**TOWN OF HERNDON, VIRGINIA
HERITAGE PRESERVATION REVIEW BOARD
PUBLIC HEARING AGENDA
SEPTEMBER 16, 2020
HERNDON COUNCIL CHAMBERS BUILDING
765 LYNN STREET
7:00 P.M.**

Subject: HPRB #20-014, 899 Station Street, Alterations to an Existing Structure

Subject: HPRB #20-015, 756 Grace Street, Alterations to an Existing Structure

Subject: HPRB #20-016, 104 Monroe Hill Court, New Construction (Site Features)

- 1) 756 Grace Street Revised Alterations Design and Materials Information

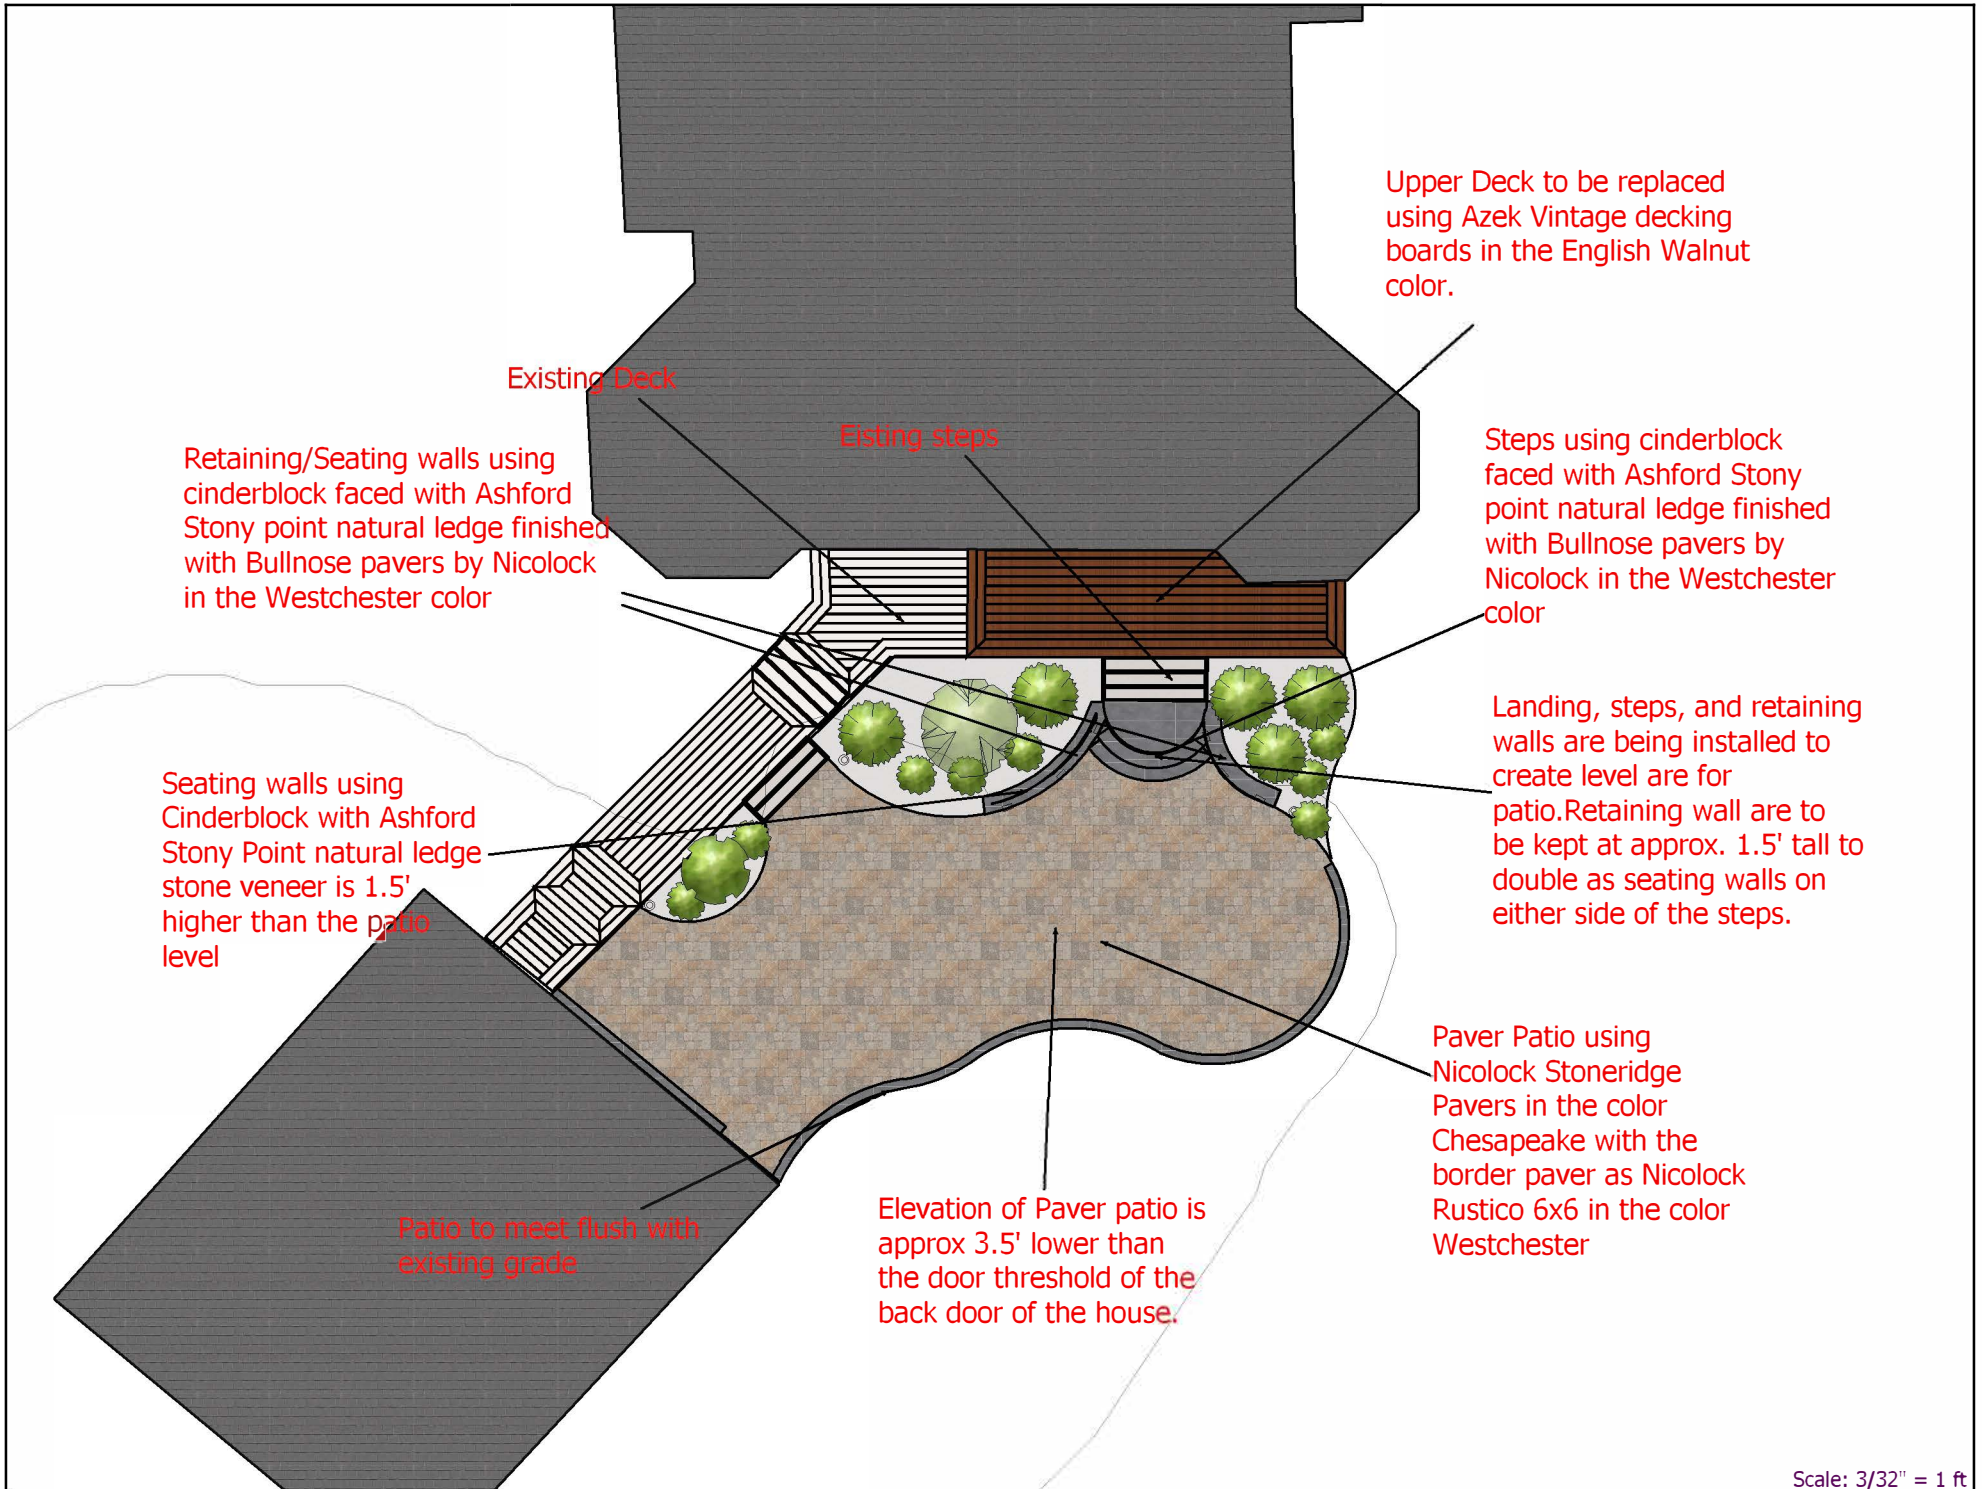
Since the work session, the applicant has provided materials information about the retaining wing walls and steps, which are to be constructed of CMU structural walls at 1.5' in height faced with Stony Point Natural Ledge stone veneer and pavers by Nicolock in the Westchester color to cap the retaining wall which will form a seat wall (as further noted in the revised materials) (Attachment #1).

In addition, the applicant has provided a sample of a cellular composite railing system previously not specified in the application and photographed in Attachment #1. The previous railing system was proposed to be vinyl railing(s) with metal balusters.

- 1) The retaining walls and steps are generally reflective of common landscape materials and finishes for rear yard features of both contributing and non-contributing properties. Staff finds that these features are generally appropriate for this property.

- 4) Staff continues to have concerns about synthetic exterior materials introduced on the visible deck components, specifically:
 - a. Staff finds the PVC wrapped railing posts, and PVC railing systems are not appropriate, and will have a plastic look and texture. Staff recommends these features be made of wood, painted to match the existing or the composite material provided as a new railing sample also painted to match the existing wood features (in Attachment #1 of the staff memo dated September 11, 2020);

- b. Staff recommends that any rail cap also be made of wood, painted to match other wood features, though not clarified in the revised materials;
 - c. Staff recommends that any fascia materials to be replaced, wrapping the floor/ceiling cavity beneath the deck be made of wood painted to match existing wood features, though still not clearly specified in the application materials; and

- b. Non-visible structural elements, specifically floor joist, may be wrapped in PVC, and no other elements;**
 - c. Stairs and retaining / seat walls shall be constructed of CMU structural walls at 1.5' in height faced with Stony Point Natural Ledge stone veneer and pavers by Nicolock in the Westchester color to cap the retaining wall as revised;**
